**From:** Neil Duffield [neil.duffield@bhdpartnership.com]  
**Sent:** 05 March 2009 13:52  
**To:** Hilary Saunders  
**Subject:** Middlerigg Farm Sneatonthorpe

**Re: Middle Rigg Farm, Sneatonthorpe**

DISCIPLINE: ARCHITECTURAL  
 CLIENT: MR K. HOWARD  
 PROJECT: MIDDLE RIGG FARM STAINSACRE LANE, STAINSACRE  
 TITLE: ALTERATIONS OF FARM HOUSE (A) PROPOSED ELEVATIONS & SECTION A-A

DISCIPLINE: ARCHITECTURAL  
 CLIENT: MR K. HOWARD  
 PROJECT: MIDDLERIGG FARM  
 STAINSACRE LANE, STAINSACRE  
 TITLE: ALTERATIONS OF OUTBUILDING B  
 PROPOSED PLANS  
 & ELEVATIONS

DISCIPLINE: ARCHITECTURAL  
 CLIENT: MR K. HOWARD  
 PROJECT: MIDDLE RIGG FARM  
 STAINSACRE LANE, STAINSACRE  
 TITLE: ALTERATIONS OF FARM HOUSE (A)  
 PROPOSED ELEVATIONS  
 & SECTION A-A

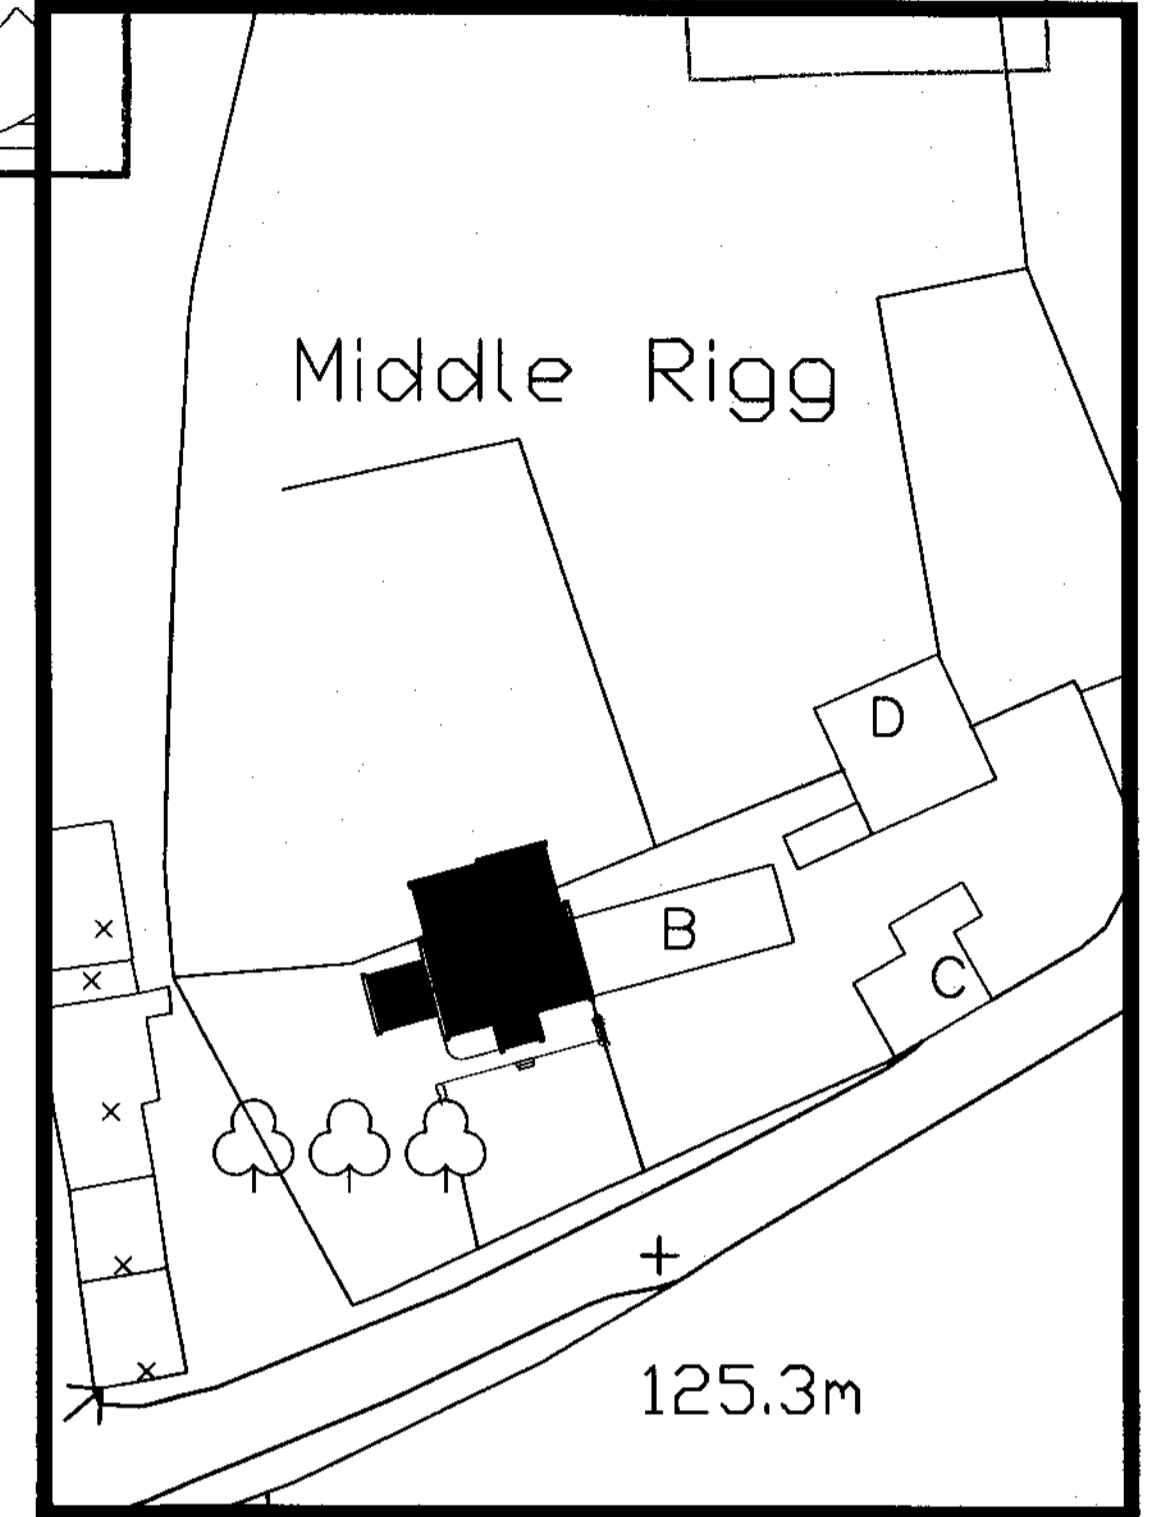
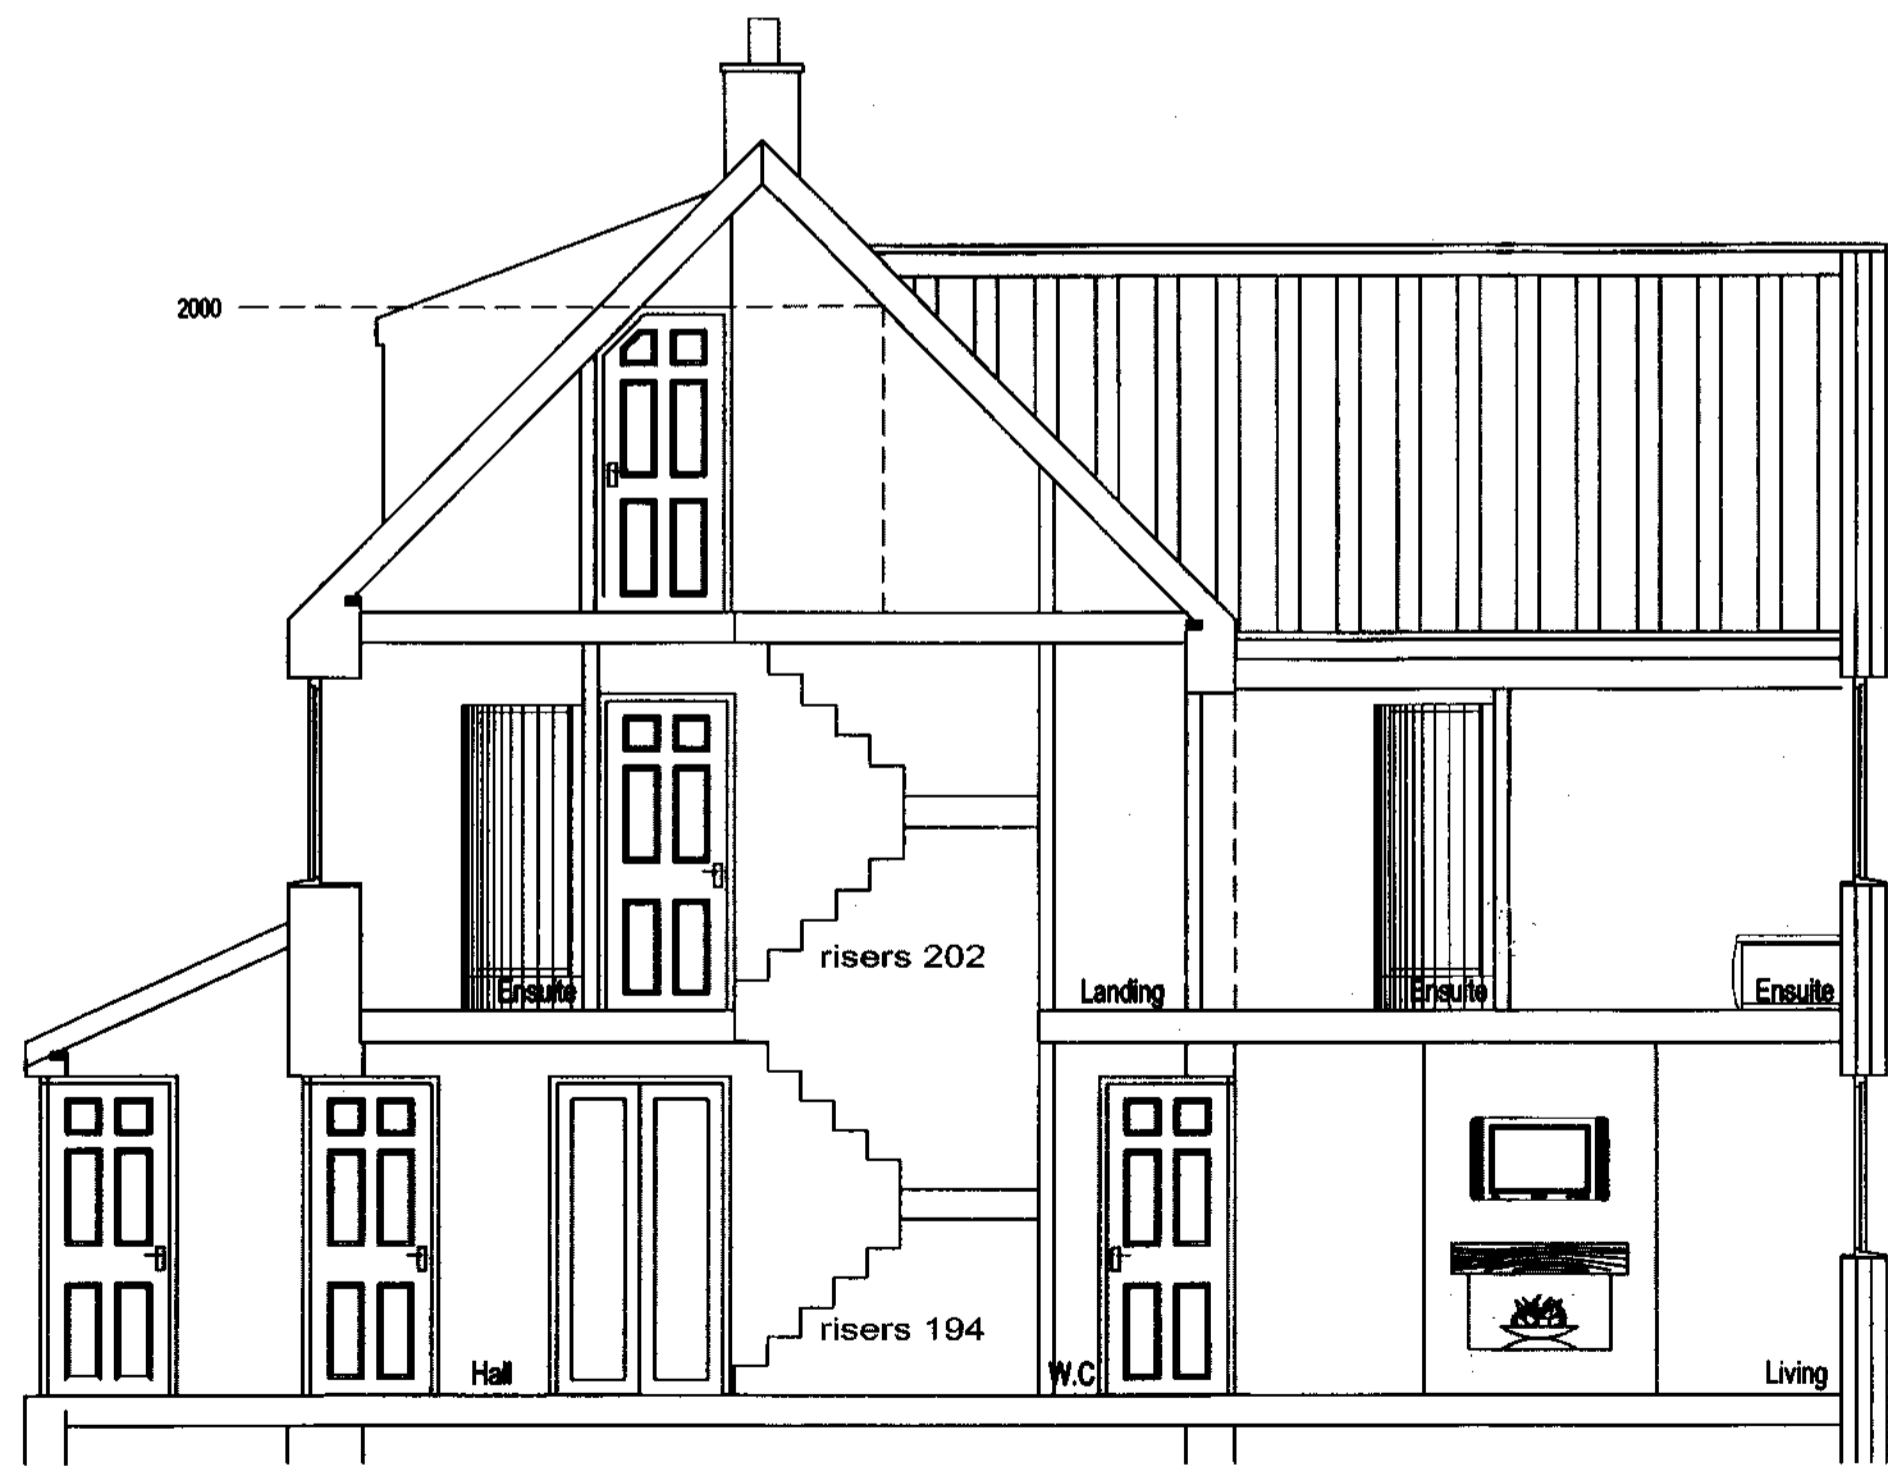
REV	DATE	BY	AMENDMENT	CHKD	APVD
C	04/03/09	KH	ROOF HEIGHT REDUCED		
B	03/10/07	GR	REVISED TO SUIT PLANNERS	KSH	
A	09/05/06	CSB	ISSUED FOR CLIENT COMMENT	NID

DISCIPLINE:	ARCHITECTURAL
CLIENT:	MR K. HOWARD
PROJECT:	MIDDLERIGG FARM STAINSACRE LANE, STAINSACRE
TITLE:	ALTERATIONS OF OUTBUILDING B PROPOSED PLANS & ELEVATIONS

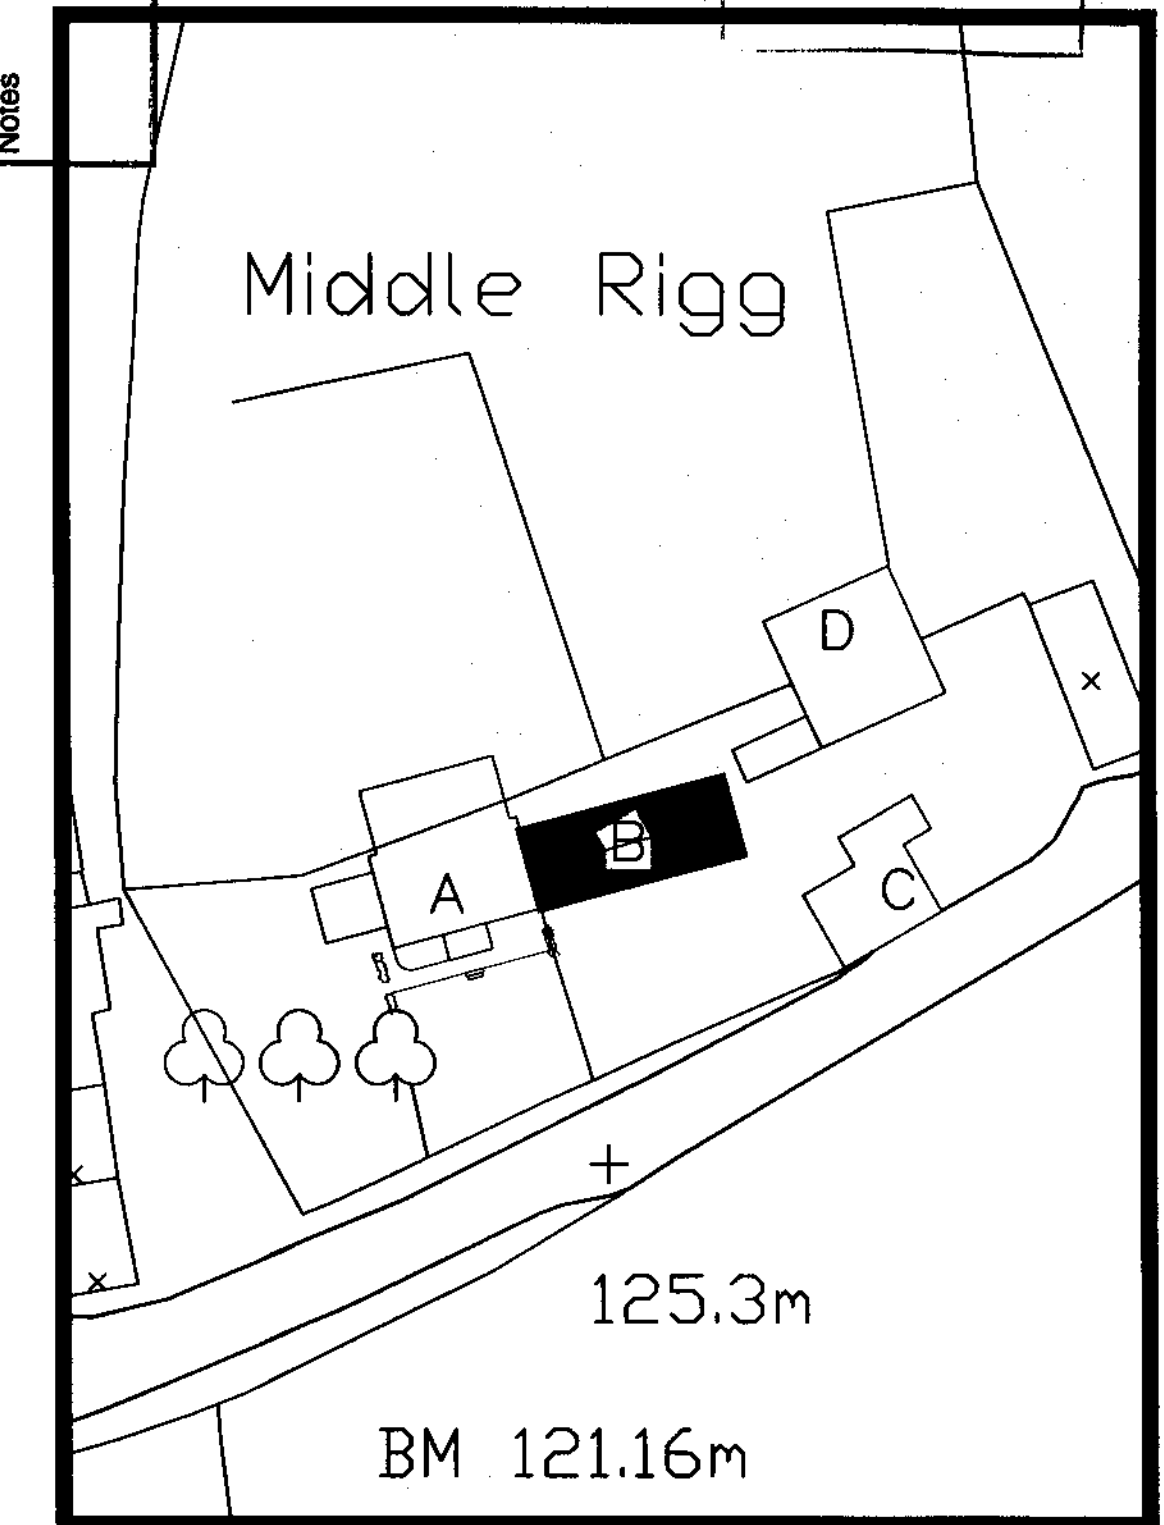
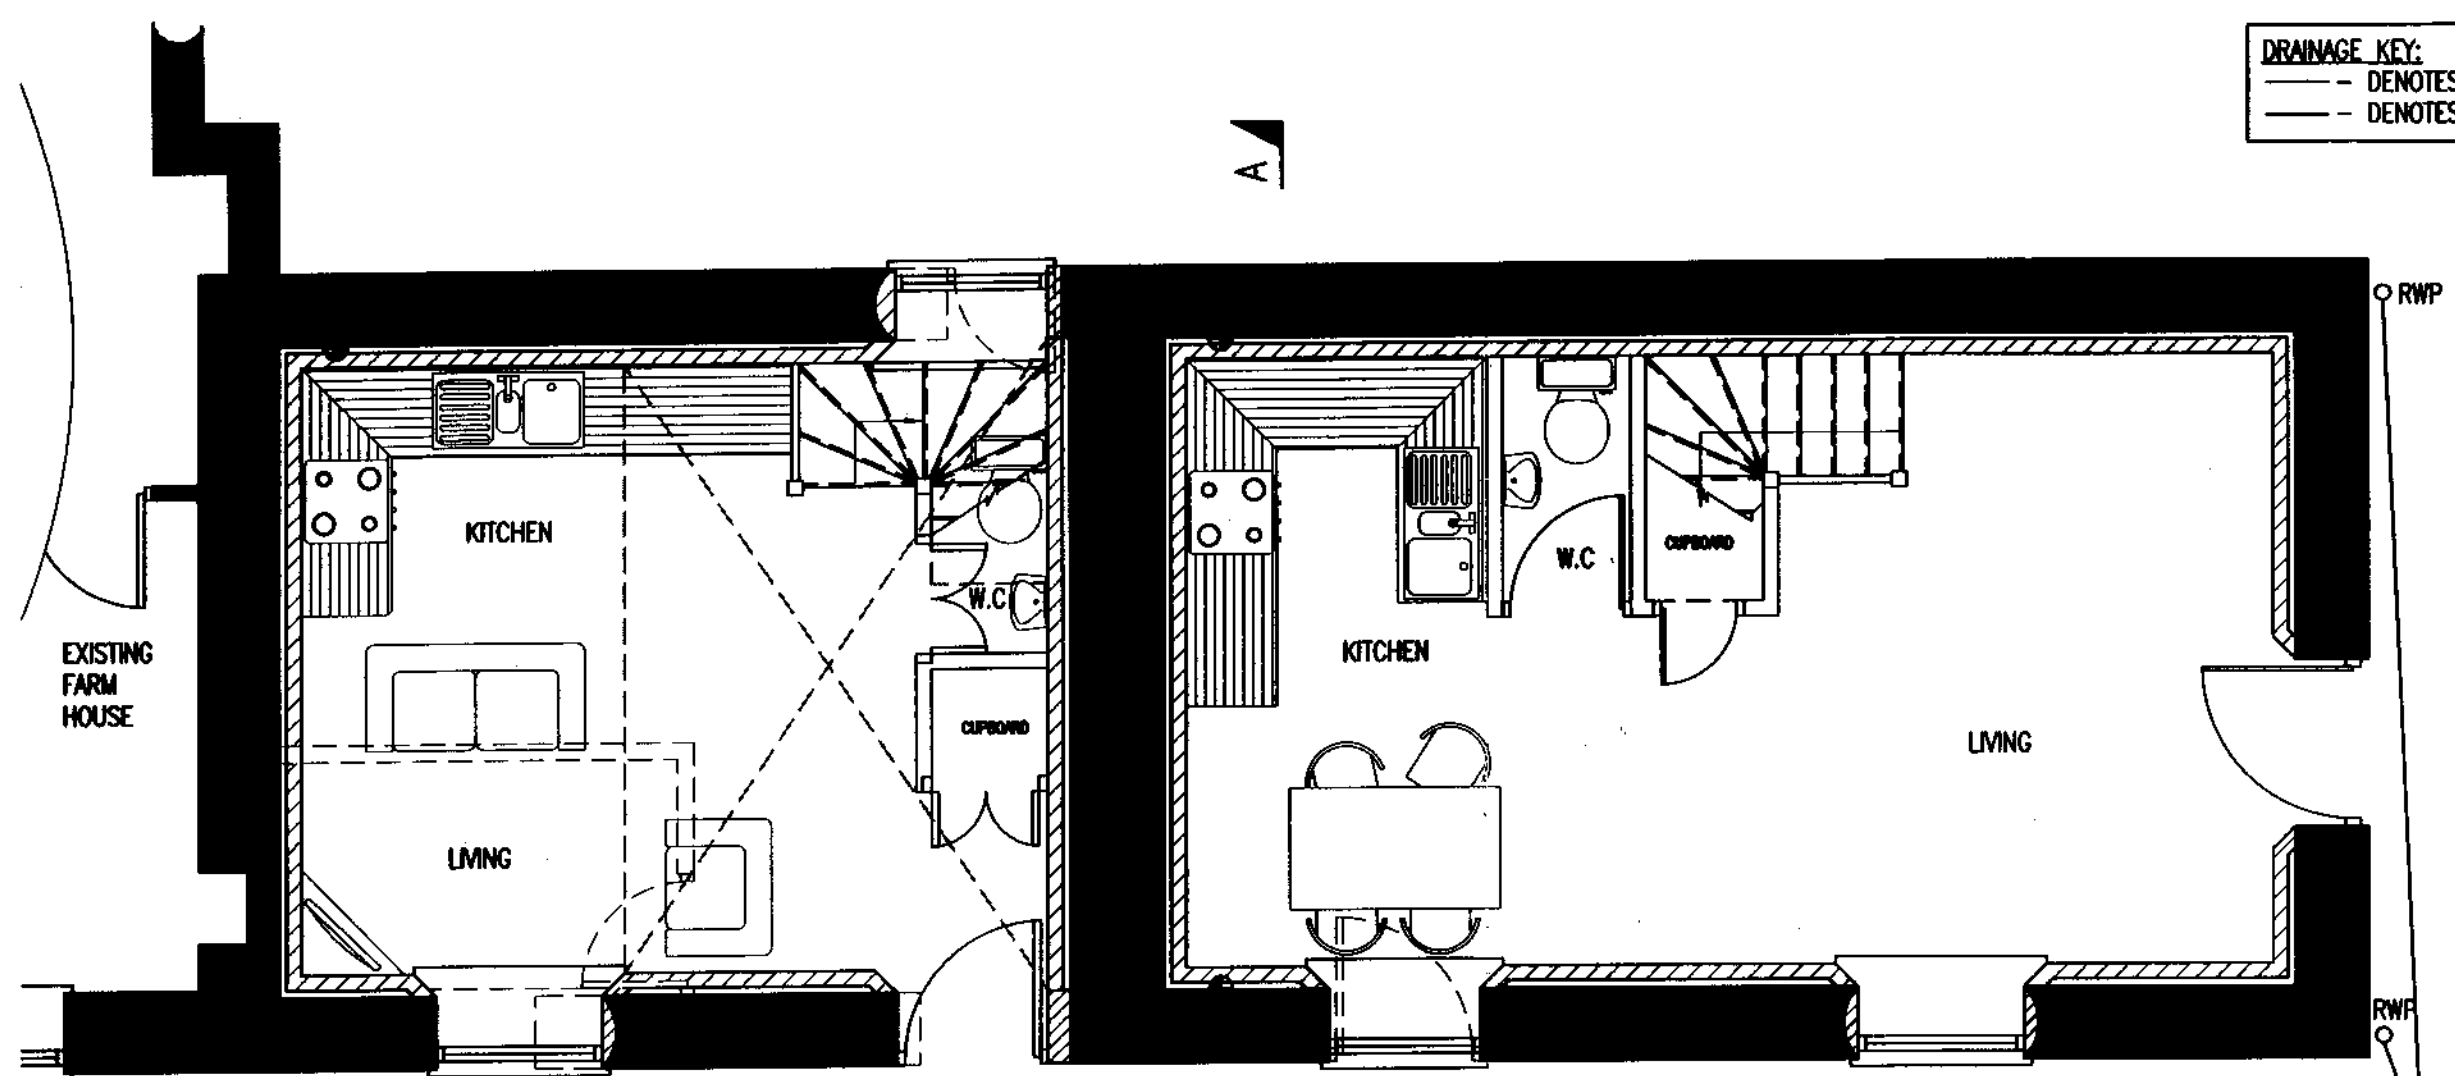
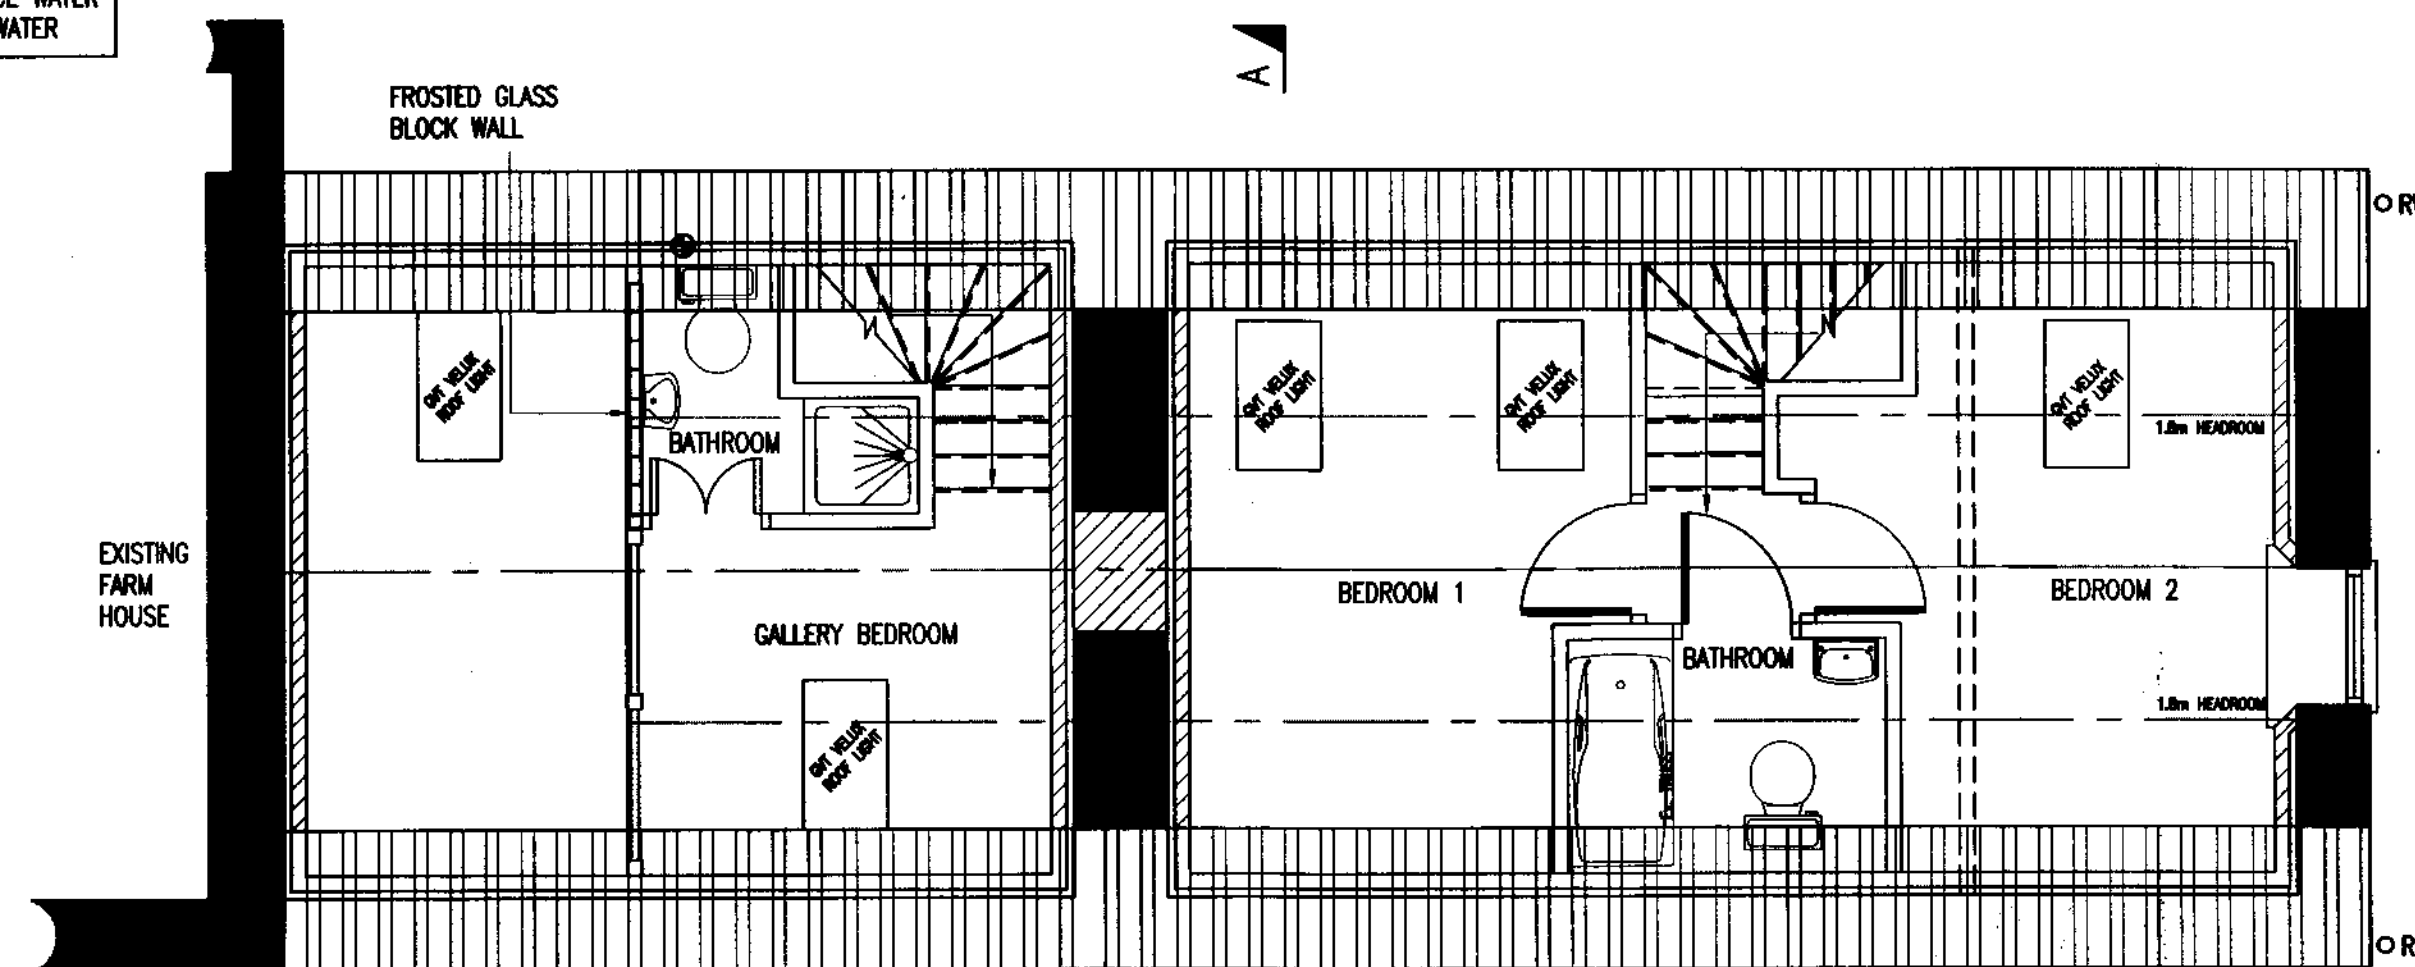
REV	DATE	BY	AMENDMENT	CRD	APD
C	04/03/09	KH	ROOFLIGHTS OMITTED		
B	03/10/07	GR	ROOF LOWERED TO ORIGINAL HEIGHT	KSH	
A	09/05/06	CSB	ISSUED FOR CLIENT COMMENT	NID
